Environment Agency

Our ref: SV/2010/103997/CS-
03/SB1-L01
Your ref:
Date: 11 November 2013

BROMSGROVE DISTRICT PLAN PROPOSED SUBMISSION DOCUMENT

Environment Agency Appendix A_Bromsgrove Source Protection Zones

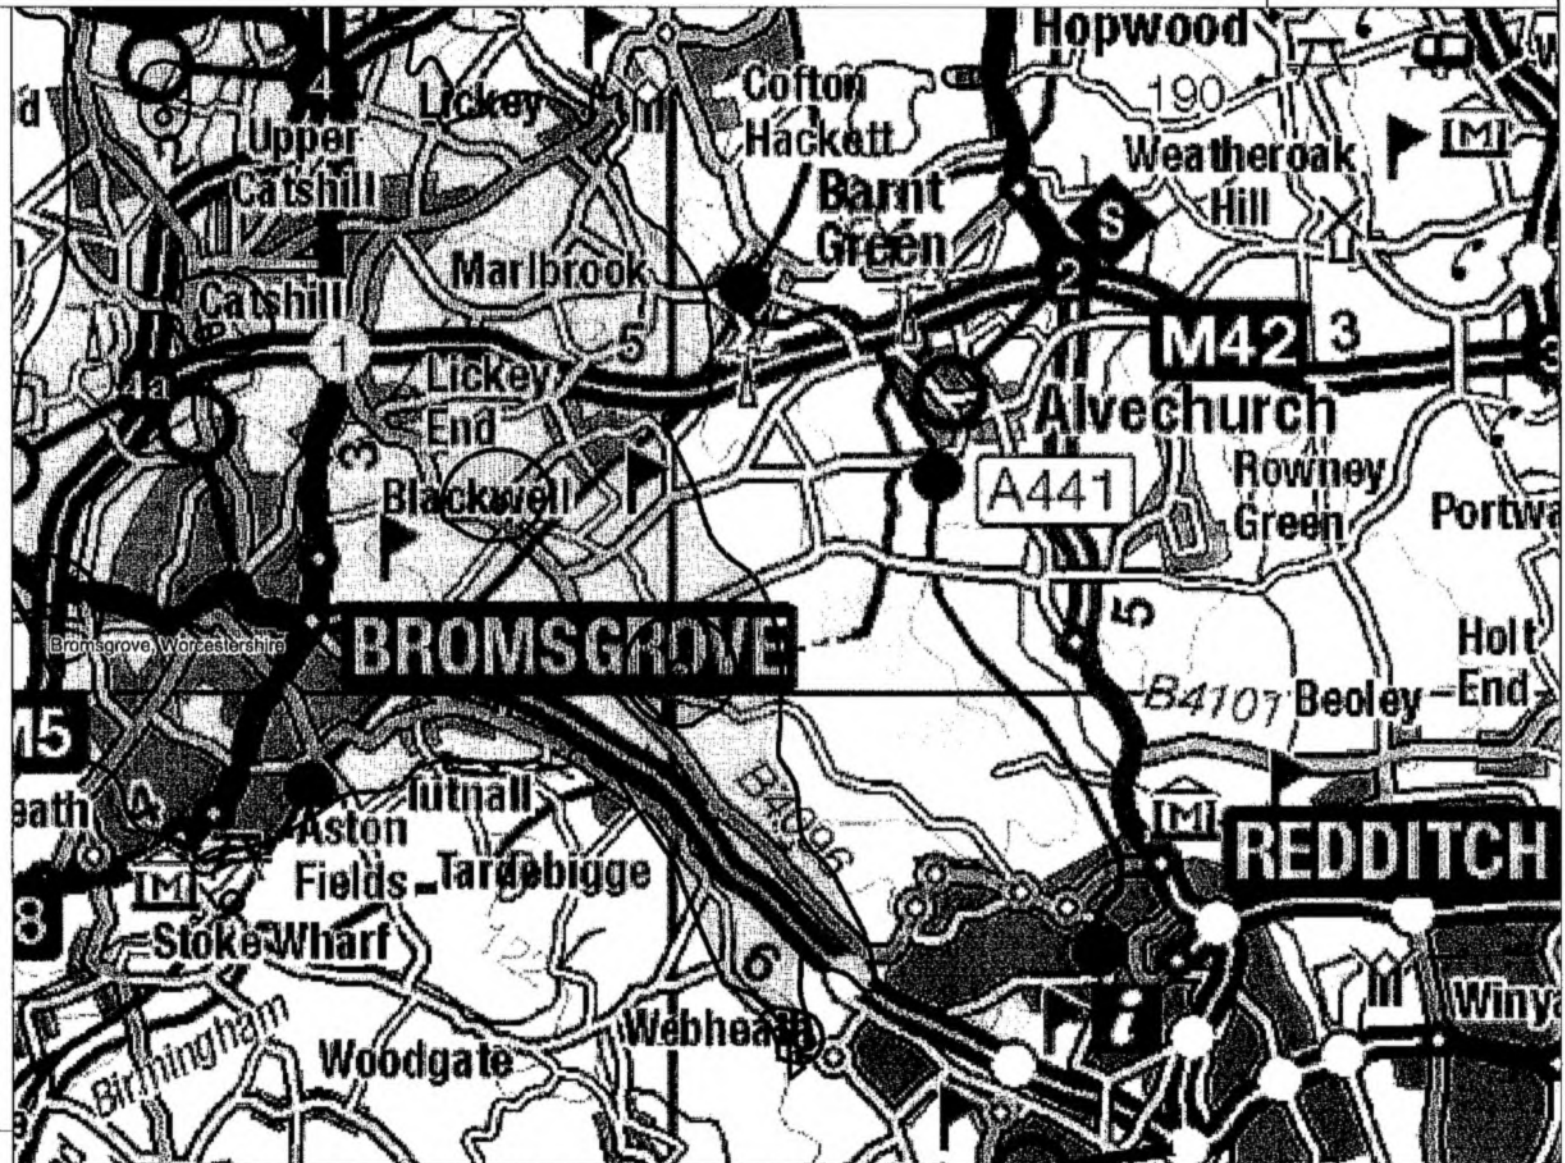
We would like to highlight that there is a licensed public water supply abstraction located within the curtilage of the existing dwelling at the north west corner of site allocation BROM3 (Whitford Road). There are Source Protection Zones associated with this groundwater source with the inner zone (SPZ1) falling within the boundary of the

dwelling's curtilage. The catchment area of this groundwater source extends across all three of the sites allocated by this policy with BROM2 and BROM3 affected by both SPZ2 and SPZ3, and BROM1 being within SPZ3.

We are concerned to note that Policy BDP5A provides no reference to the SPZs on the sites and makes no reference to the poor quantitative status of the groundwater body under the WFD. We consider that in its current form BDP5A does not take into account the sensitive hydrogeological setting of the area and its vulnerability to the effects of new development.

- Updated maps are provided to supplement the policy, including indicative masterplan showing the location and extent of SPZs, and including appropriate restrictions for certain development types within SPZs
- Appropriate risk assessments and site investigations should be required to identify any previous contaminative history
- A SuDS scheme including appropriate treatment and measures to ensure recharge to aquifer. A risk assessment to identify pollution risks associated with proposed development i.e contaminated run off, foul drainage, etc.
